Access Review

Multi-dwelling Development
8 Linksvie Avenue Leonay
Report Issue 5
31/03/21

This proposed development at 8 Linksview Avenue Leonay is being undertaken by Glenstone Group and consists of 5 independent living units.

Footpath Link to Public Transport

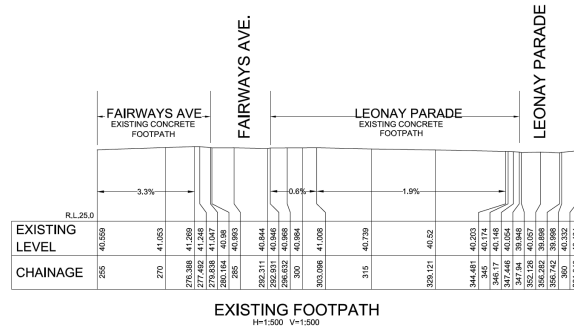
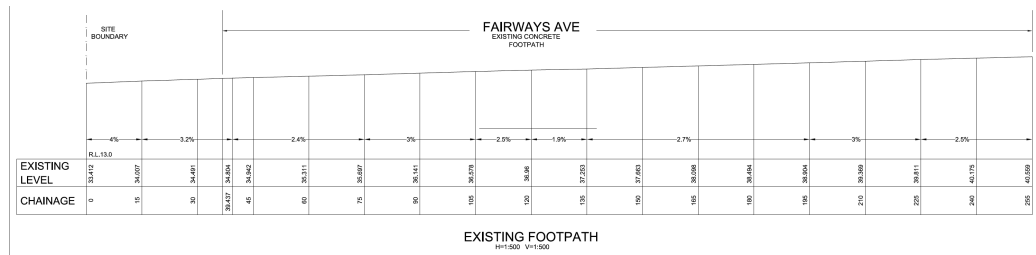
The contour and detail survey prepared by RHCO Surveyors (excerpt on following page) shows that the gradient of the existing and proposed footpath (0.6% - 4%) is within the allowable gradients set out in State Environmental Planning Policy - (Housing for Seniors or People with a Disability) 2004 part 2 clause 26 of:

Based on the survey information provided and inclusion of the proposed design of the new section of footpath, in our opinion the site complies with the requirements set out in the State Environmental Planning Policy - (Housing for Seniors or People with a Disability) 2004 part 2 clauses 26 and 38 for location and access to facilities.

Excerpt from Survey of footpath gradient from proposed development to bus stop on Leonay Parade prepared by RHCO, dated 13/02/20

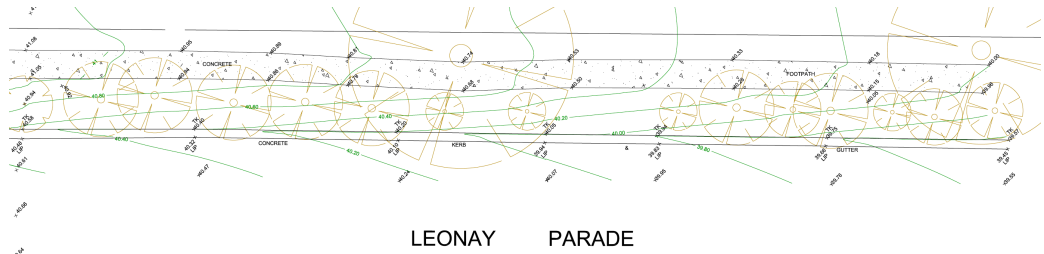
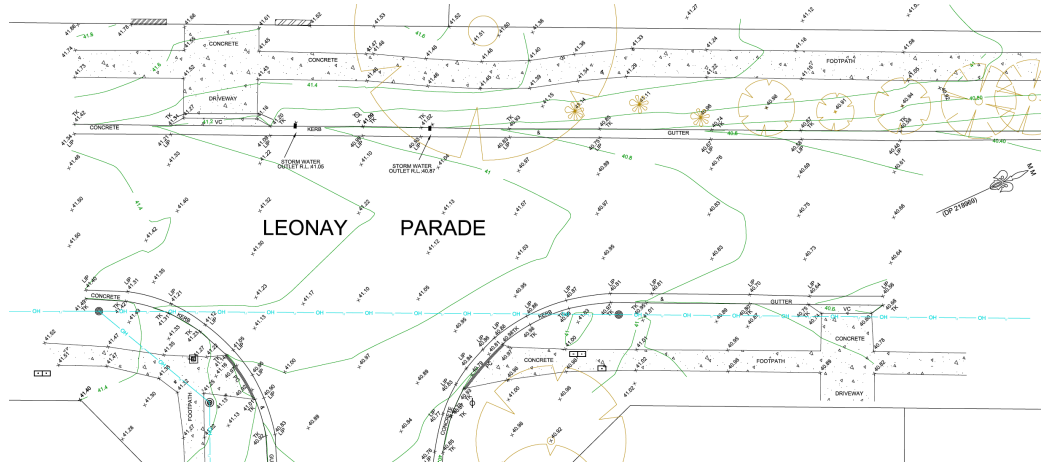
Footpath levels from site to the bus stop on Leonay Parade
